SUBJECT: Appl 25224

25224

Looking Upstream

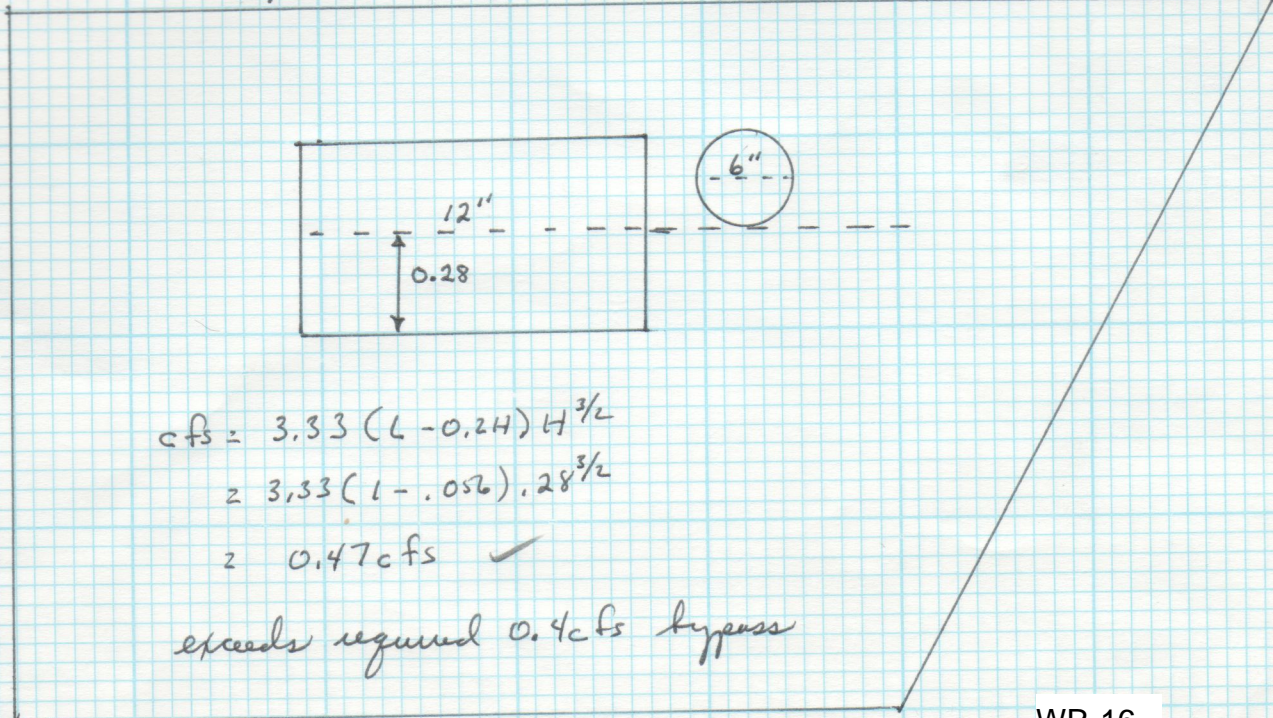
M Enclosed are two Requests for License. Please have an authorized person
E sign and return one. The second is for the clips records. Also, need
S a picture of the completed weir. Please send so we can continue the license
S process. If you have any, questions, please contact me
A
G
E

*This is constructed
as I told him. Will bypass
0.4 cfs prior to fully open*

$$\begin{aligned} cfs &= 3.33 (L - 0.2H) H^{3/2} \\ &= 3.33 (1 - .056) .28^{3/2} \\ &= 0.47 cfs \quad \checkmark \end{aligned}$$

exceeds required 0.4 cfs bypass
